Request for Quote
Special District Engineering Services
Issue Date December 21, 2021

Below are responses to questions submitted by potential RFQ respondents. This document is being updated as questions are received, please check back regularly for additional responses. A final version of this question and responses sheet will be issued on January 14th, 2022.

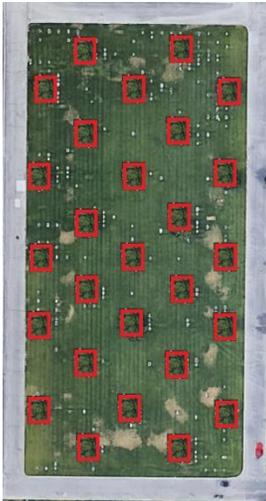
- 1. The last sentence of the RFQ states that the cemetery has room for soil displacement. Will the excess soil generated from the bulk excavation be able to remain in this location permanently, or is this area a temporary location to store the soil? I would like to make sure I don't have to account for off-site soil export.**

We have a huge "pit" on our undeveloped land that needs backfill. It is not readily visible in the overhead shot attached ("Pit"), but I have highlighted the area with a red box that is about 10 feet deep. We believe we have more than enough room for displacement of dirt.
